California Department of Transportation

Re: Pie Ranch Master Plan — Draft Mitigated Negative Declaration (MND)

Thank you for including the California Department of Transportation (Caltrans) in the environmental review process for the Pie Ranch Master Plan. The Local Development Review (LDR) Program reviews land use projects and plans to ensure consistency with our mission and state planning priorities. The following comments are based on our review of the August 2026 Draft MND.

MASTER PLAN
SCALE: 1" = 80'

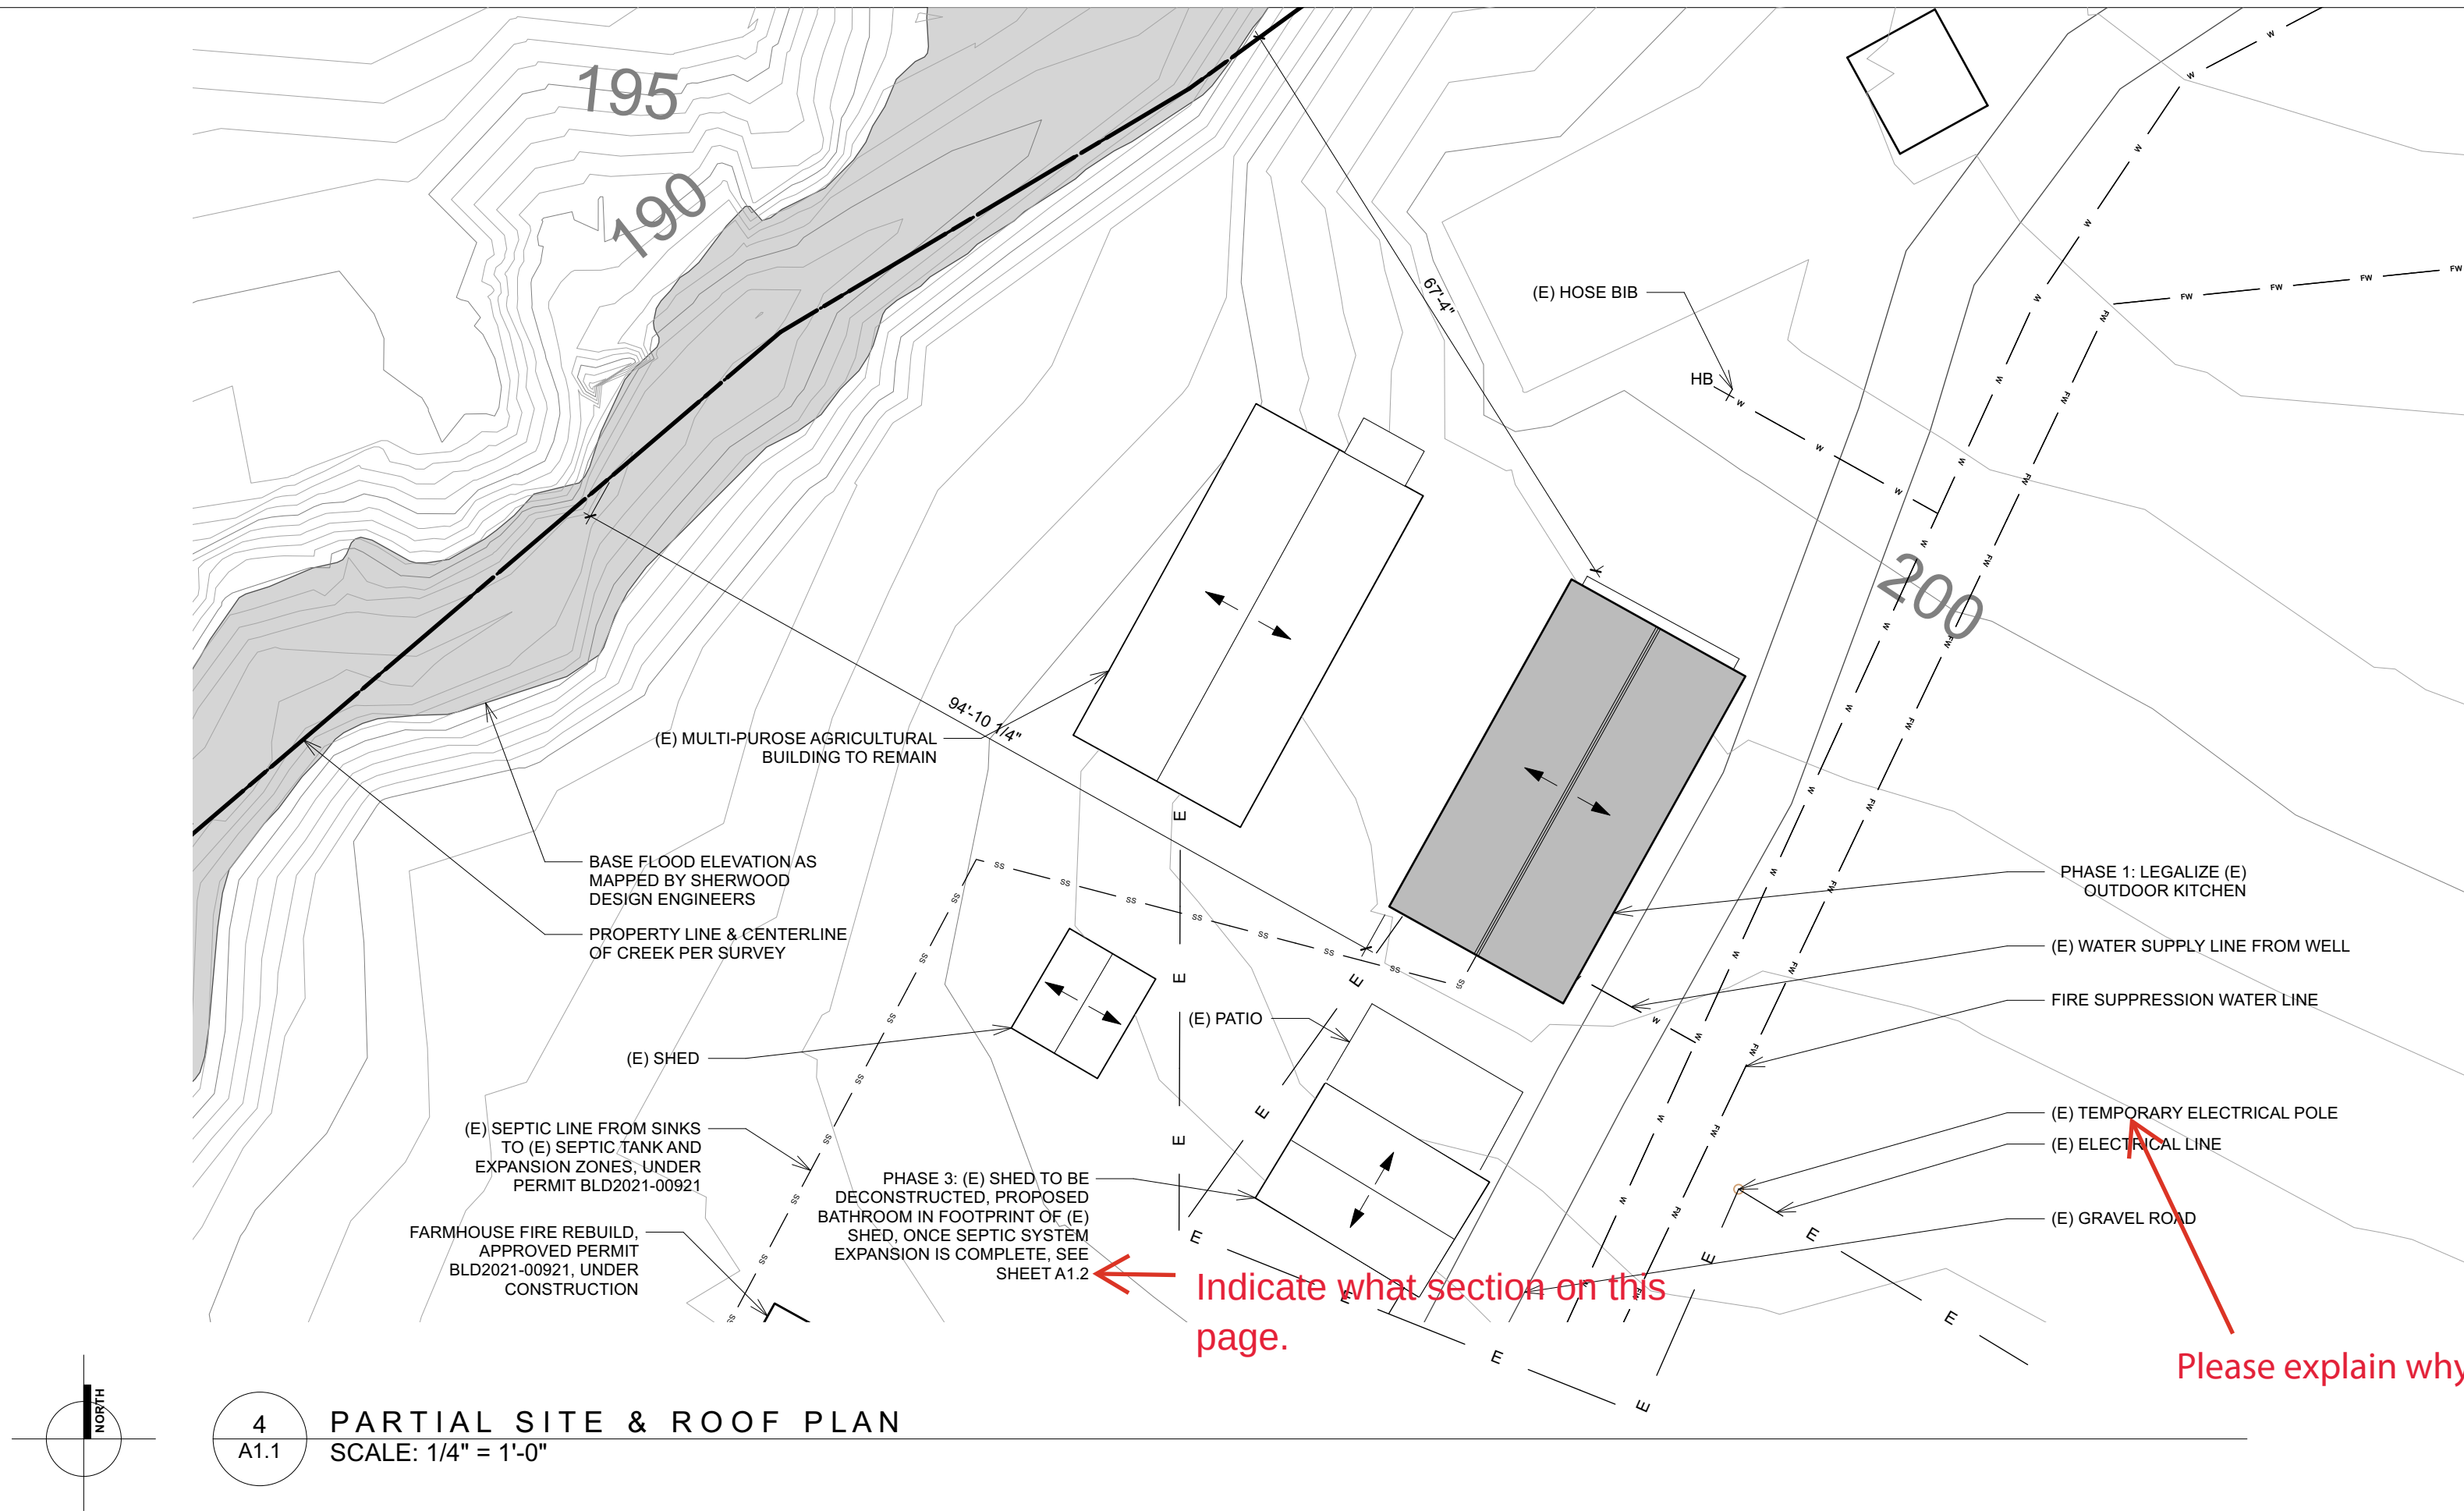
Would this line be impacted by proposed construction?

Label the CT RW line?

Please include the address of this ranch somewhere on this front sheet

Label this structure

State whose property line?
